**Before the
FEDERAL COMMUNICATIONS COMMISSION
Washington, D.C. 20554**

)MM Docket No. 99-325

***Digital Audio Broadcasting Systems
And Their Impact on the Terrestrial
Radio Broadcast Service***

Figure 10. 1st-adjacent compatibility - subjective evaluation results of audio recordings obtained in the field (speech programming)

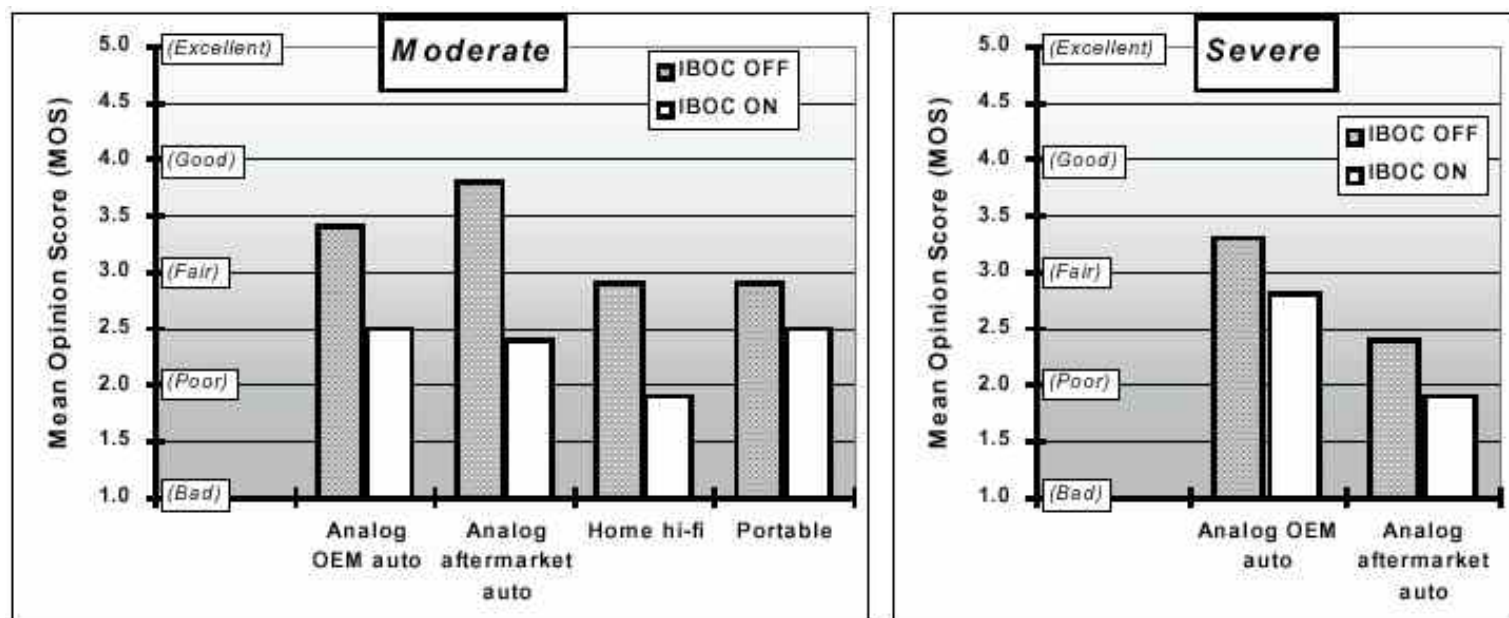
We comment that Fig 10 below (From the NRSC report, dated 3 Dec. fails to support the NRSC's own conclusion that "With respect to carriers that are located 1st adjacent to an IBOC signal, listeners within the protected contour SHOULD NOT PERCEIVE an impact on the analog host signal..." and that "(only) "A limited number of listeners MAY PERCEIVE an impact outside the protected contour" are not proven by any OBJECTIVE test, but rather improperly rely on SUBJECTIVE psychoacoustic (Noise Masking) test criteria. We comment that the public's right to continued use of the FM broadcast band will be severely impaired. We offer further comments below on the improper testing, delineated by our use of asterisks(**)
